100 GRAY'S INN ROAD

NON-MATERIAL PLANNING AMENDMENTS

This document has been prepared in support of the application for non-material amendments (NMA) to the development at 100 Gray's Inn Road and 127 Clerkenwell Road, as well as the refurbishment and extension of 88 Gray's Inn Road (2022/4259/P).

Approved - West Elevation L09 Facade Edge Detail

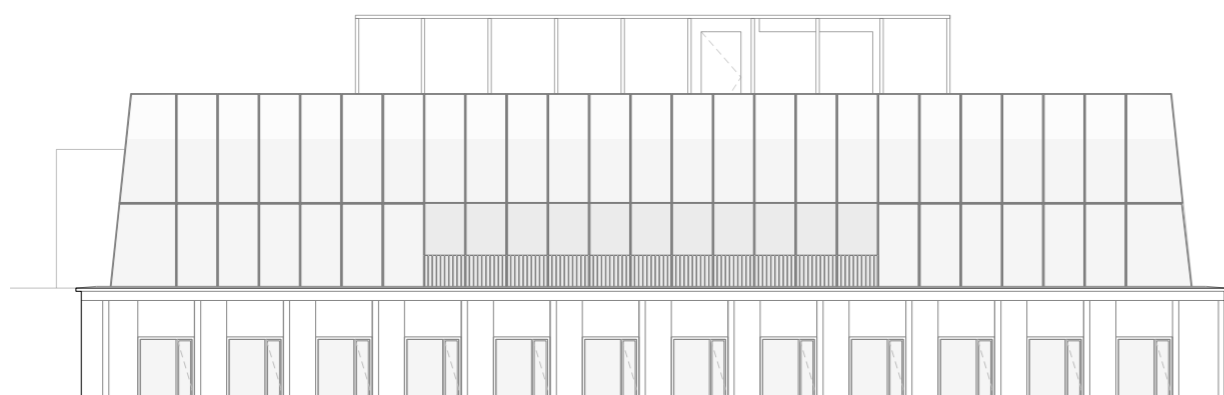
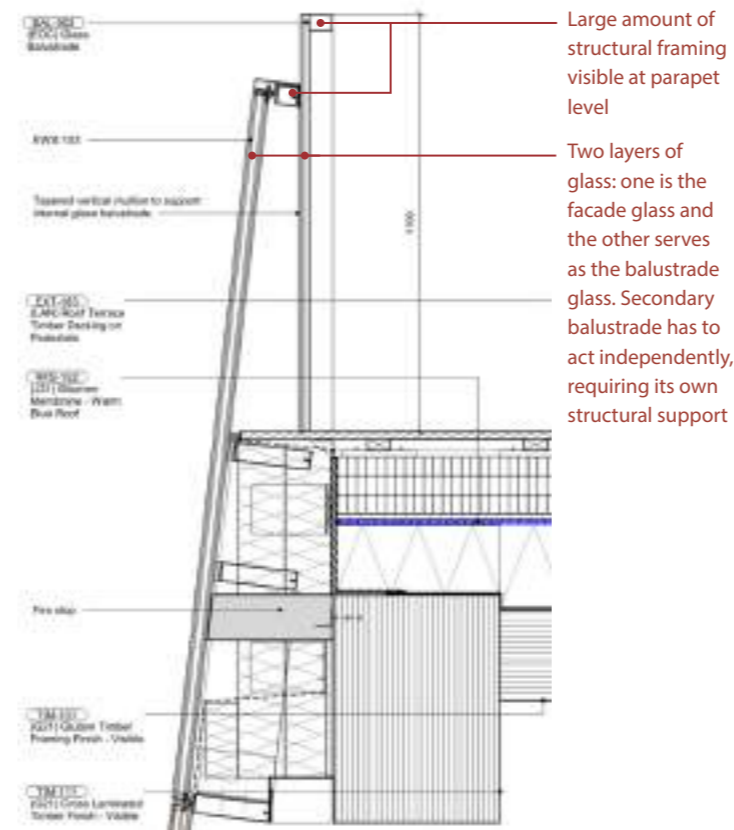
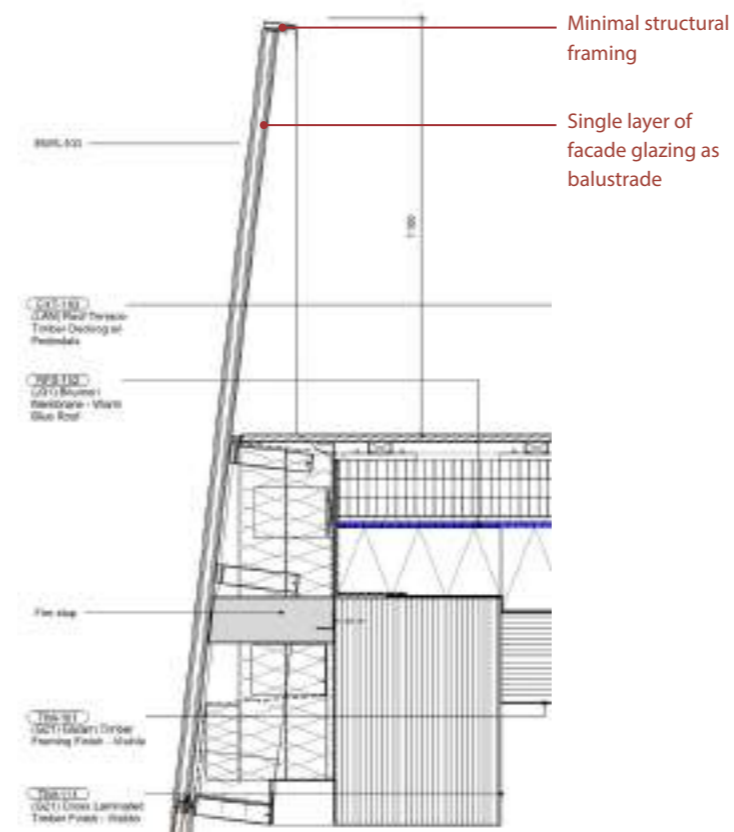
Description of Change:
Simplification of roof crown balustrade design to create a level rather than inclined balustrade

Reason for Change:
Simplifying the roof crown balustrade design represents a significant improvement from both technical and design perspectives. Currently, the roof crown has an inclined design, with the glass facade extending up to the roof terrace and reaching the minimum balustrade height at one end, but sloping down by 400mm at the other end, resulting in insufficient height. This necessitates an additional inset glass balustrade. Through technical design and contractor input this balustrade and its framing has become thicker and heavier than anticipated in the planning stages which detracts from the overall aesthetic and comfort of the terrace space. As illustrated on the left, the doubling up of structural framing creates a heavier balustrade design

The proposed design features a levelled glass facade at balustrade height, eliminating the inclined slope. Omitting the secondary balustrade, opting for a single balustrade that is lighter in appearance than the approved design. This streamlined approach enhances the visual cohesion and comfort of the terrace, removing the need for multiple layers of glass and doubling up of structural framing creating a more pleasing and unified design.

Proposed - Roof Floor (Level 09) Plan

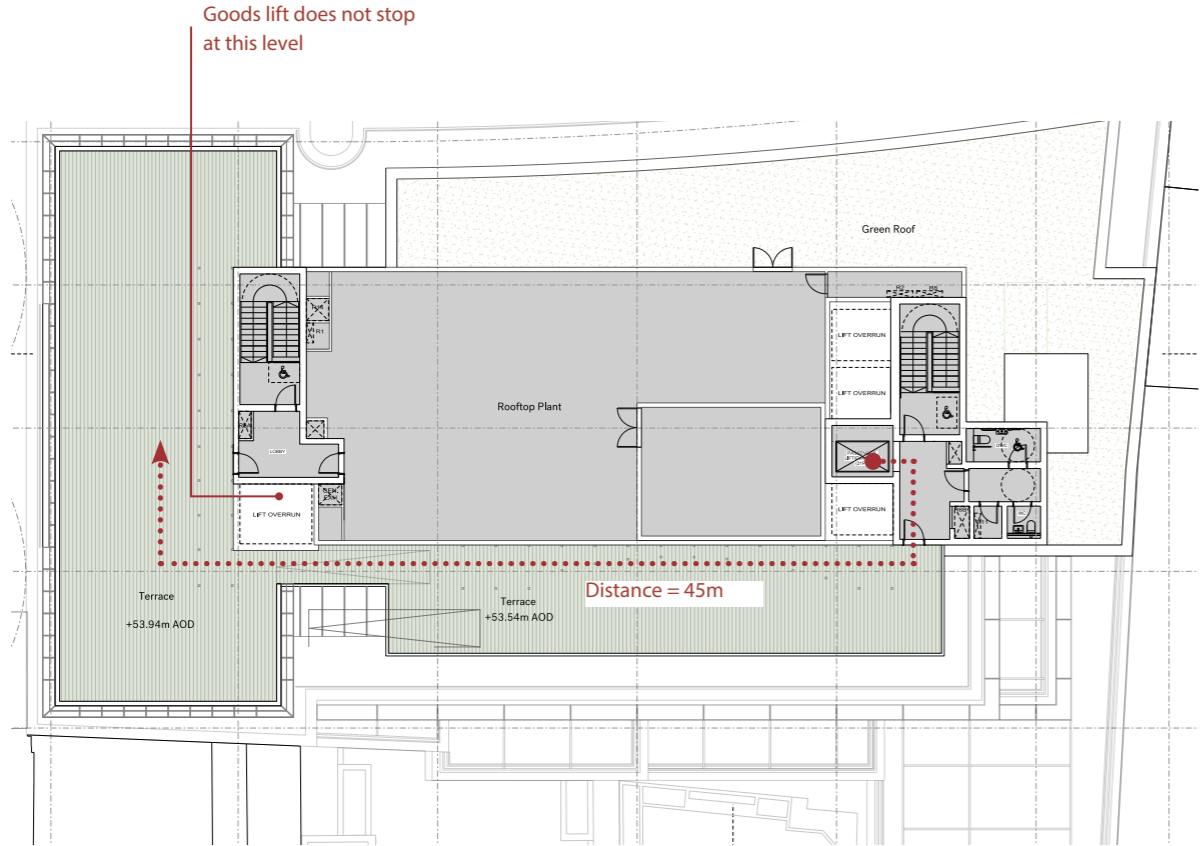
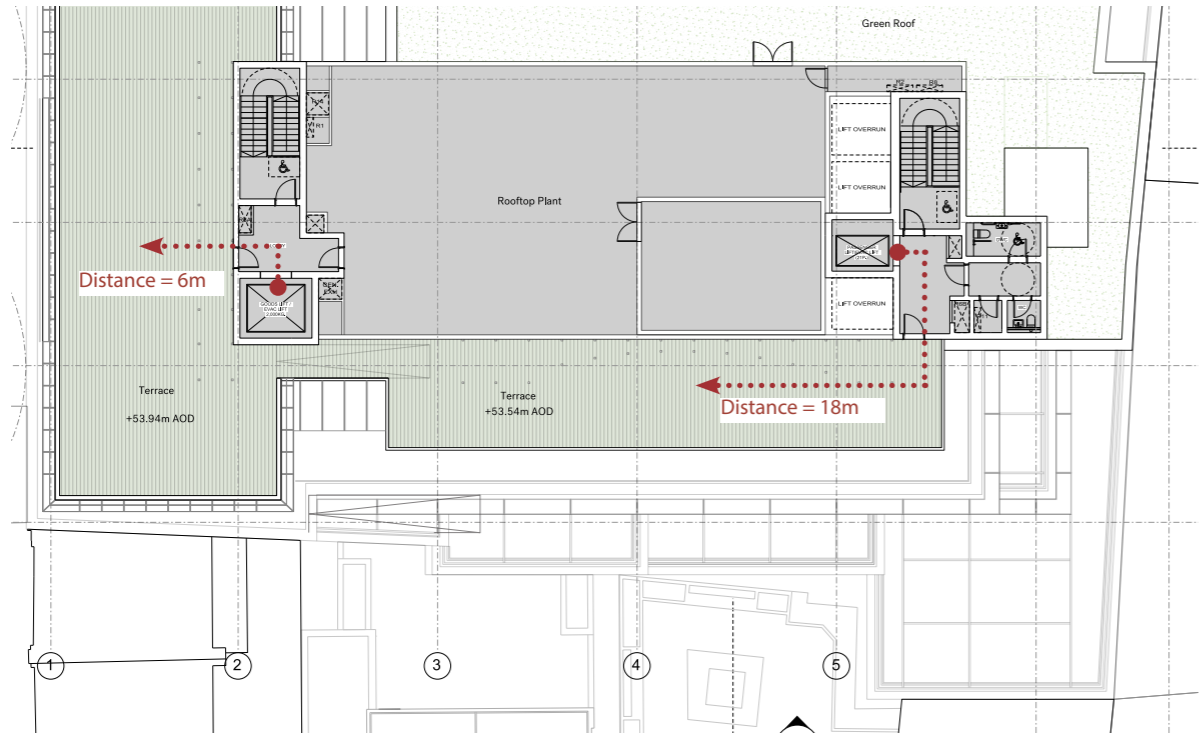
Description of Change:

The goods lift will be increased to provide direct lift access to the Level 09 Roof Terrace.

Currently, only the main lift core of the building currently serves all floors up to Level 09 roof terrace. The secondary lift core is equipped with the goods lift that currently only operates between the basement floor and Level 08. The proposal is to extend the goods lift in the secondary lift core to serve Level 09 (roof terrace) to meet the latest UK building regulations and enhance the building’s safety, operational efficiency, and compliance.

Proposed - South Elevation

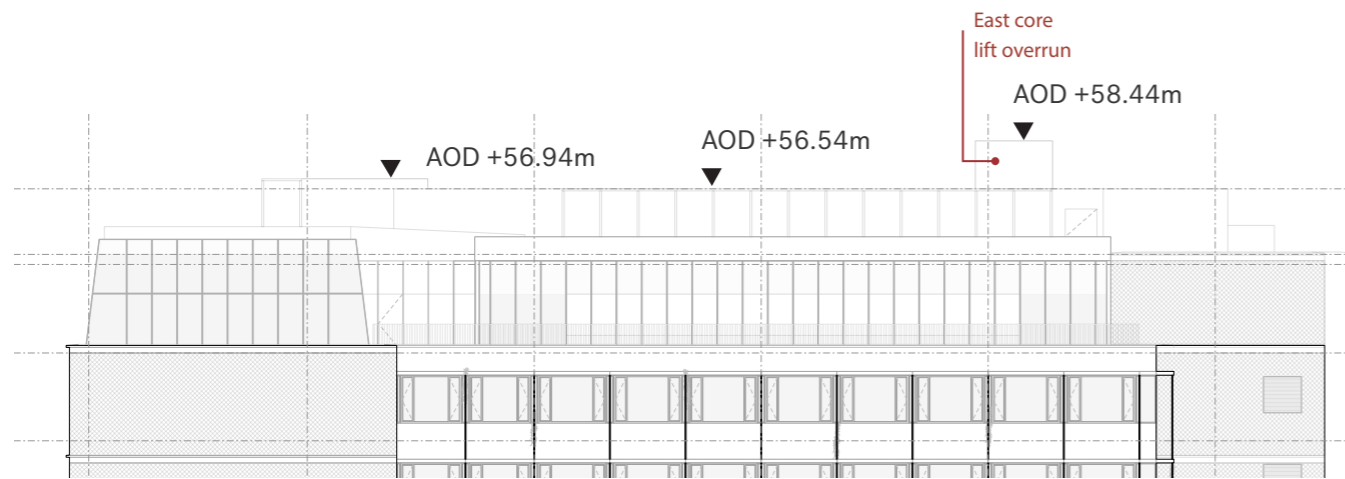
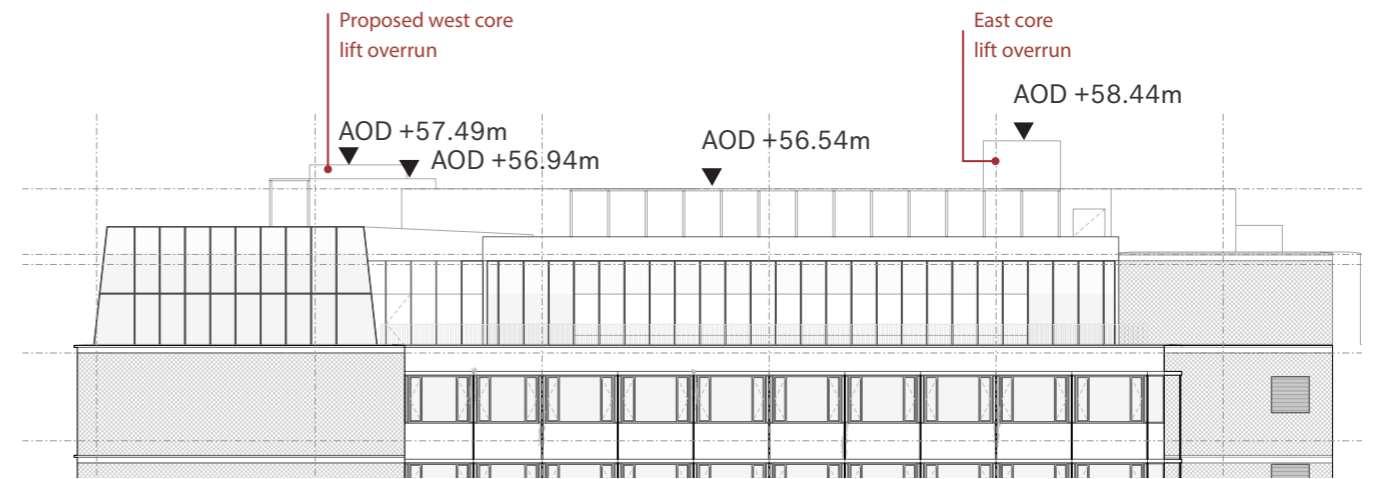
This image showcases the proposed levelled crown and goods lift to roof terrace (L09)

Proposed - Level 08 Floor Plan

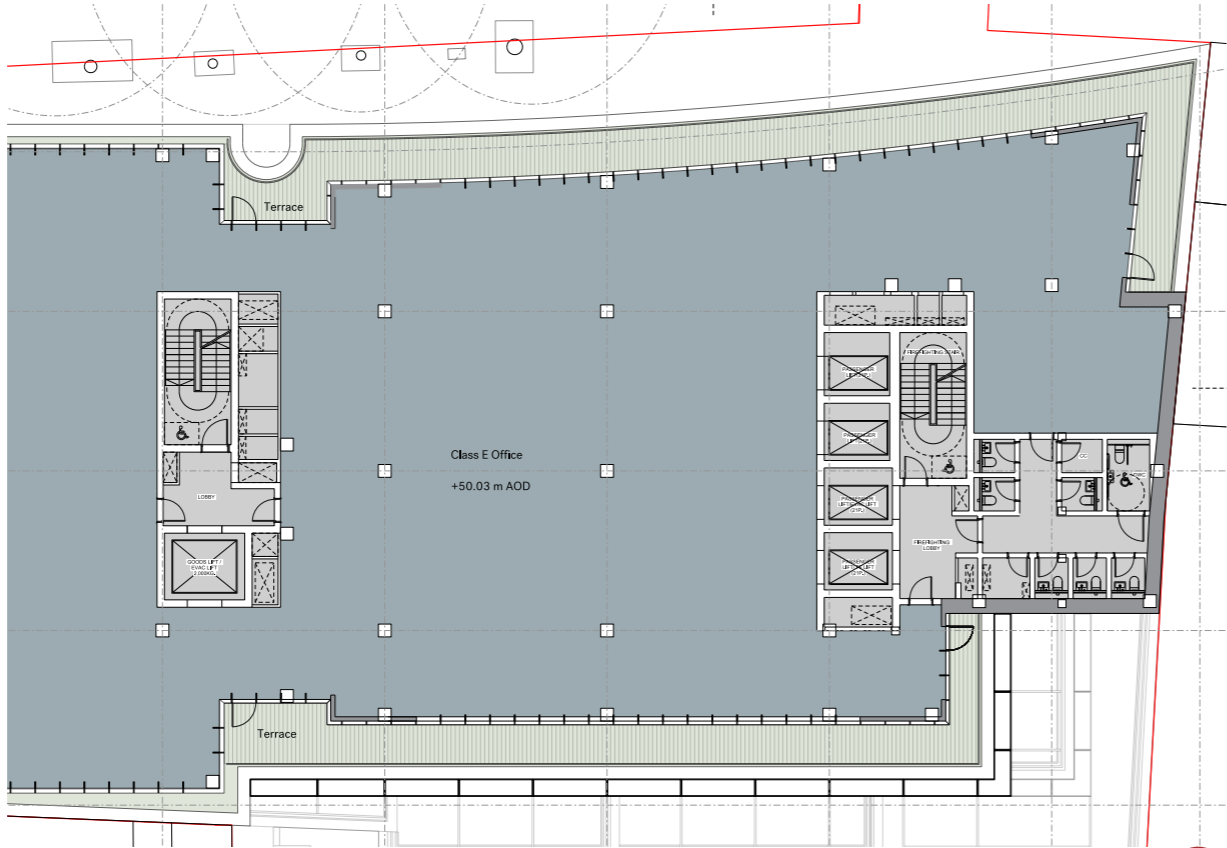
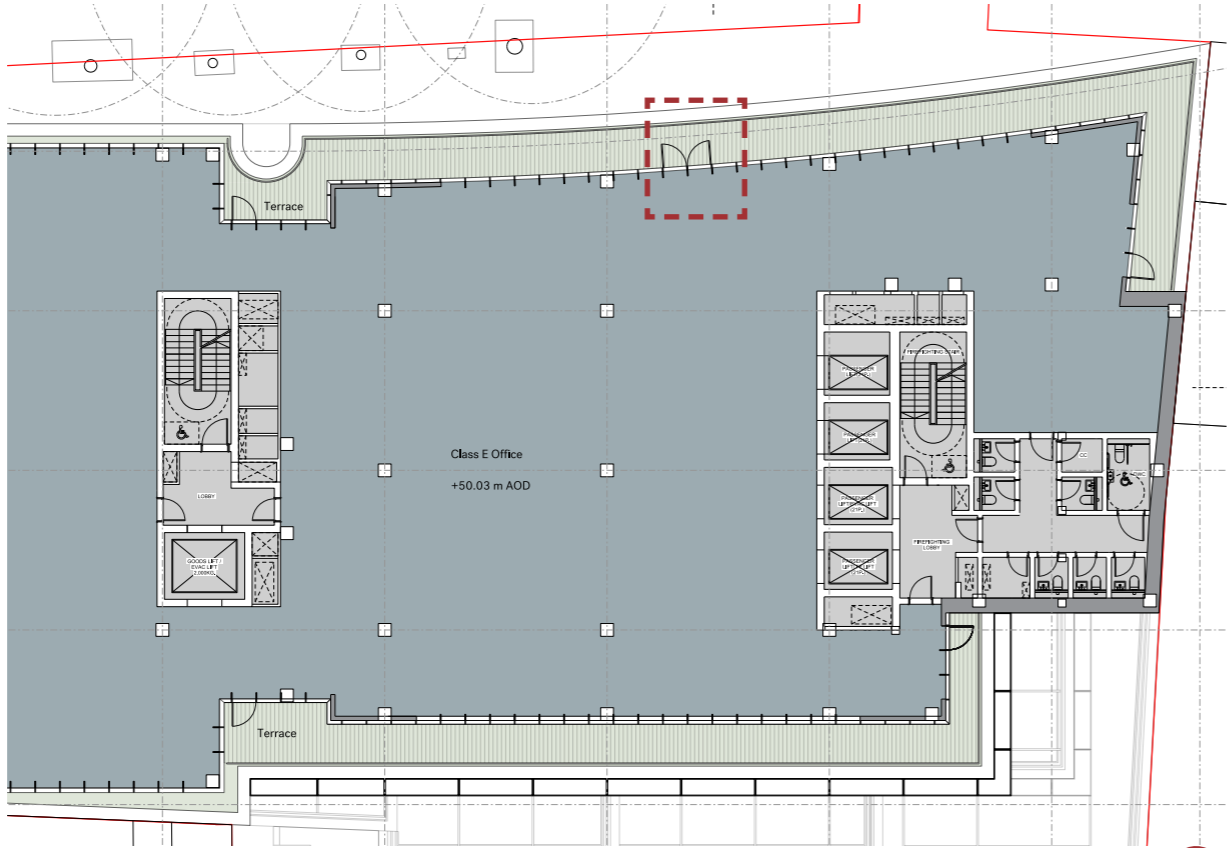
Description of Change:
 Introduction of new doors to access the terrace on Level 08 (for tenant flexibility).

Reason for Change:
 The introduction of new doors to access the terraces on Level 08 is designed to enhance tenant flexibility and ease of use. These new doors provide additional access points to terraces that already have access, ensuring that privacy and overlooking concerns remain unchanged. Currently, the design has doors justified to one side, so adding more doors will make it more convenient for users to access the terraces from various points.
